3.1 DA18134 – 8 Allen Street, Bicheno

Planning Assessment Report

Proposal:	Additions & Alterations to Dwelling & Outbuilding
Applicant:	MyBuild Homes
Location:	8 Allen Street, Bicheno
Planning Document:	Glamorgan Spring Bay Interim Planning Scheme 2015 (Interim Scheme)
Zoning:	General Residential Zone
Application Date:	26 June 2018
Statutory Date:	28 September 2018 (by consent of applicant)
Discretions:	Three
Attachments:	Appendix A – Application documentation
Author:	Theresia Williams, Consultant Planner

Diagram 10.4.2A. Building envelope as required by subclause 10.4.2 /

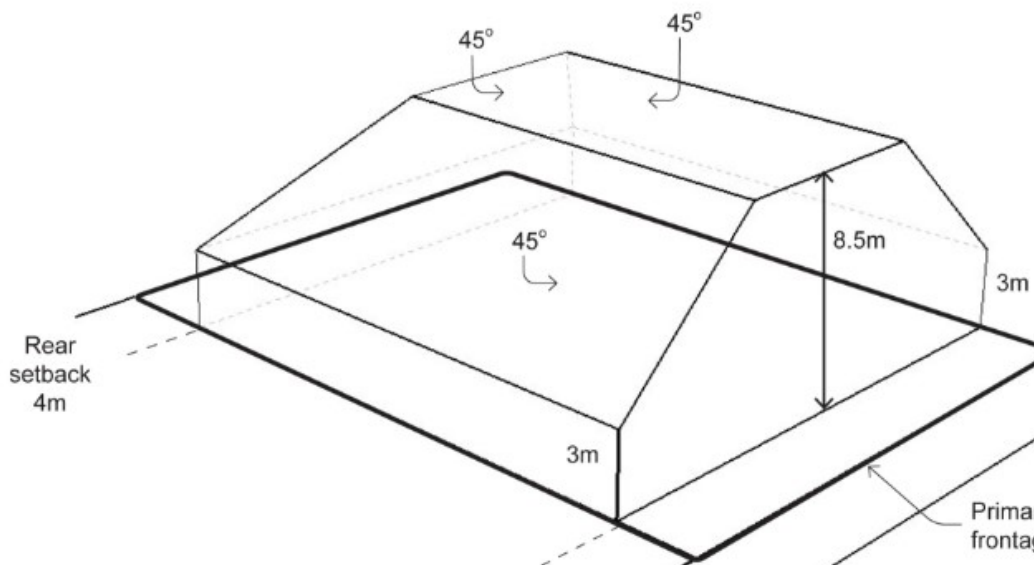
7.9.2. The existing proposal before Council includes a design which sits outside the Building Envelope prescribed in the Acceptable Solution.

7.9.3. The existing residence already sits outside this building envelope. The proposal would reduce this setback of the deck to the adjoining property from (approximately) 10cm to 0cm

7.9.6. The proposal sits outside the building envelope when viewed in relation to a small corner of the proposed second storey, the stairs at the front and the extension along the western side.
